Vacuum Switch Replacement on Blower Unit for Power Direct Vent Water Heaters

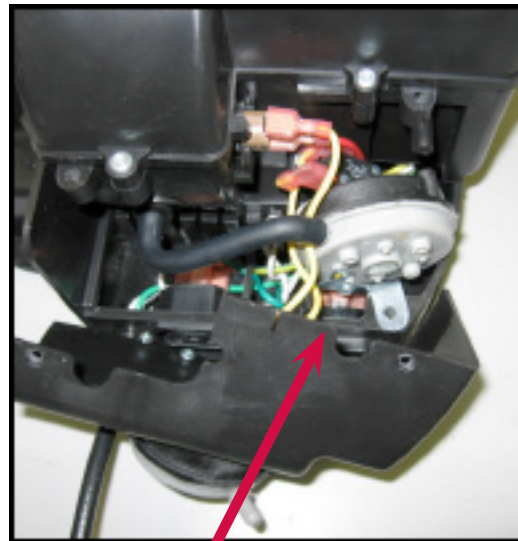
1. The intake vacuum switch that was set at -1.00" wc (No. 61074197) will be replaced with one set at -1.30" wc (No. 61074225). This switch is located outside of the electrical box on the blower unit.
2. The exhaust vacuum switch that was set at -1.40" wc (No. 61074198) will be replaced with one set at -1.10" wc (No. 61074126). This switch is located inside of the electrical box on the blower unit.

Intake vacuum switch

Exhaust vacuum switch
